# Providence City Plan Commission

May 16, 2023

## AGENDA ITEM 5 ■ 50 BRANCH AVE

Site Plan

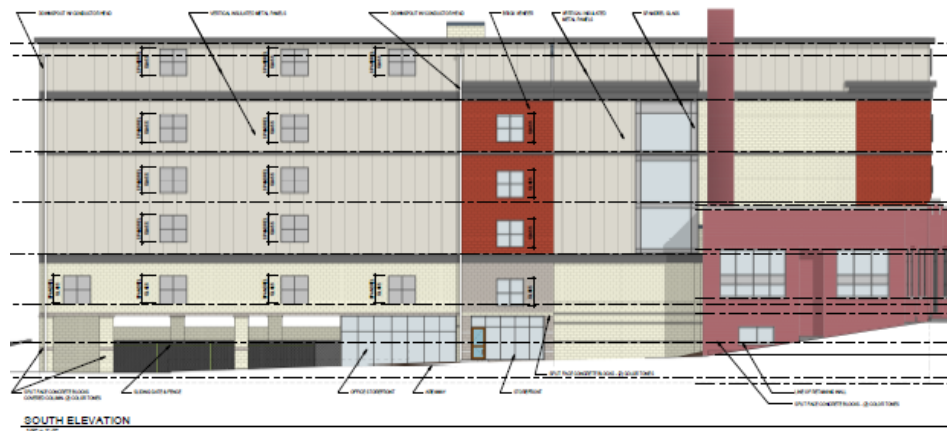
The lot is located at the corner of Branch Ave and Dryden Lane. There is a grade difference of approximately 11’ between the front and rear lot lines. Most of the building’s rear is proposed for demolition with approximately 103’ of the building’s frontage on Branch Ave, and 40’ on Dryden Lane to remain. This portion of the building will be incorporated into the proposed structure. The building will be set to the front and side lot lines and run with the grade of the lot, with pedestrian access provided from Branch Ave and access to the internal parking area provided from Dryden Lane.

According to the landscape plan, a total of eight trees with shrubs and bushes will be installed in the front, side and rear yards. A row of plantings will be located in the expanded side yard setback adjacent to the pedestrian walkway. A total of 5,400 SF of canopy coverage will be provided which will meet the canopy coverage requirement of 5,250 SF.

Two loading spaces are required as the building will provide over 100,000 SF of space. The loading spaces are identified at the rear of the parking area.
